GOLDEN GLOW FARM SUBDIVISION, **RESUBDIVISION OF LOTS 41 & 42**

APPLICATION NUMBER 10 DATE September 6, 2007

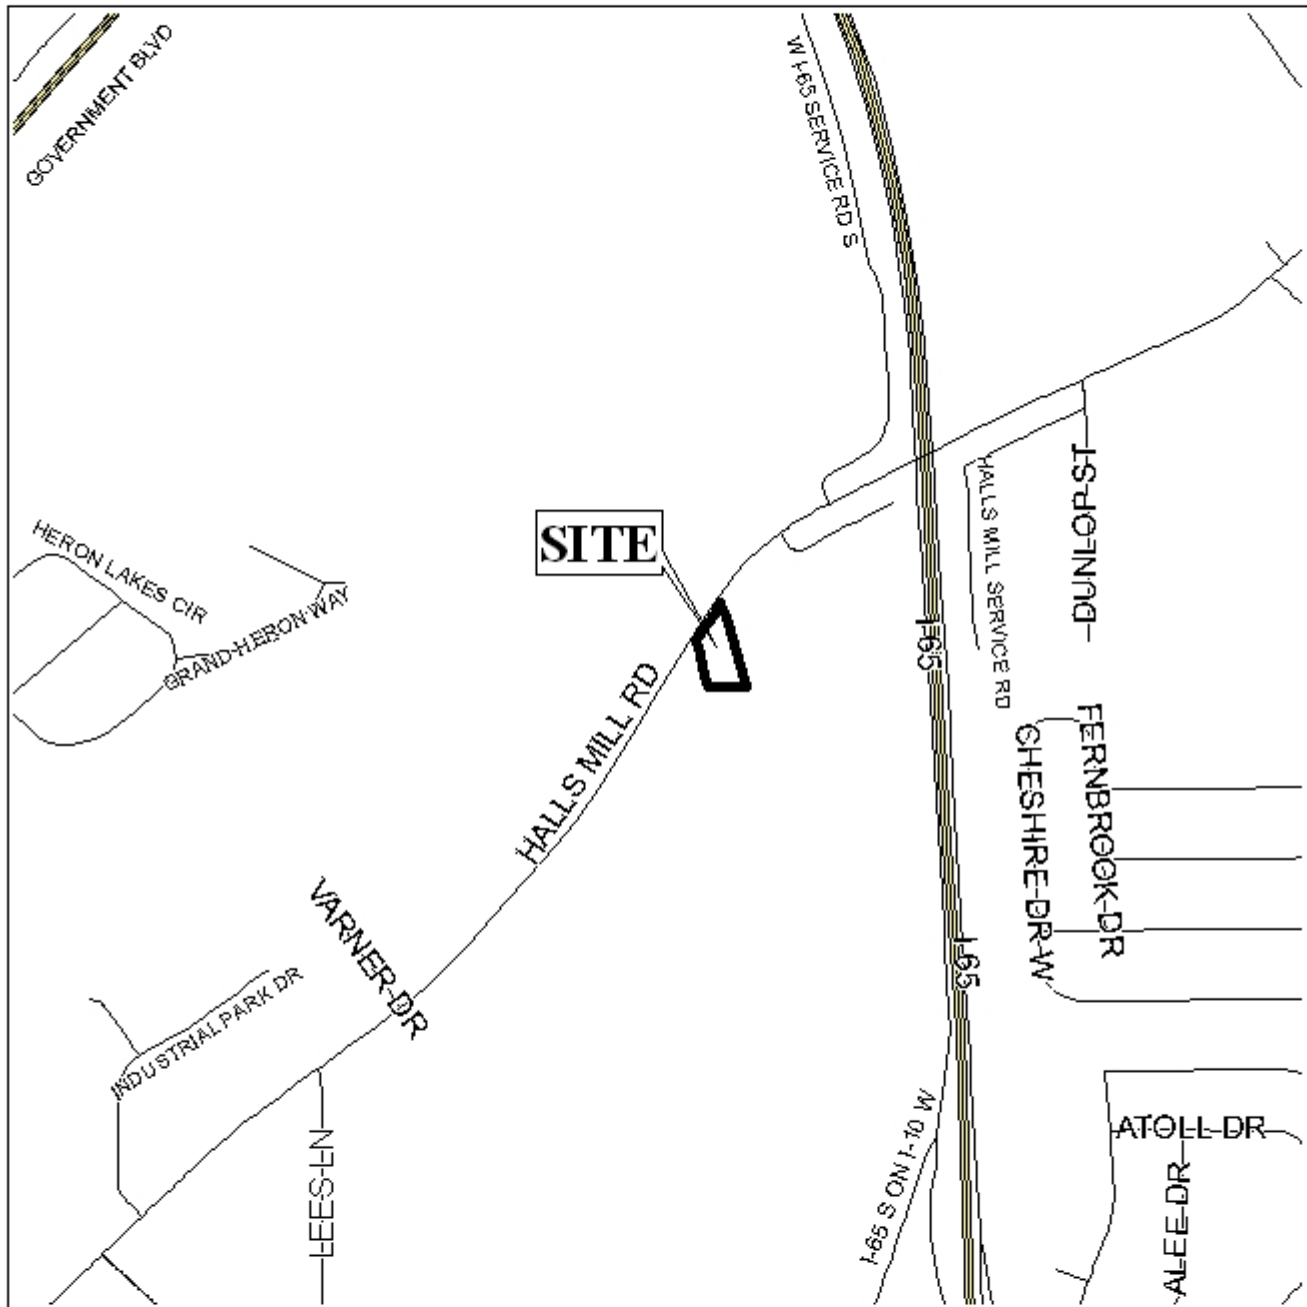
The site fronts onto Halls Mill Road, a collector street, which currently has a 50' right-of-way in this area. As a collector street, the right-of-way should be a minimum of 70' wide, thus dedication of sufficient right-of-way to provide 35' as measured from the centerline of Halls Mill Road should be required. The plat did not indicate a minimum building setback line. The minimum building setback line should be indicated on the final plat as being measured from the new right-of-way line, after dedication.

As shown on the plat, the site has less than 200 linear feet of street frontage; therefore the site should be limited to one curb cut with the location, size, and design to be approved by Traffic Engineering and conform to AASHTO standards.

1. dedication of sufficient right-of-way to provide 35' as measured from the centerline of Halls Mill Road;
2. the depiction of the 25' minimum building setback line, as measured from the right-of-way line after dedication;

3. placement of a note on the final plat stating that the subdivision is limited to one curb cut to Halls Mill Road, with the size, location, and design to be approved by Traffic Engineering and conform to AASHTO standards;
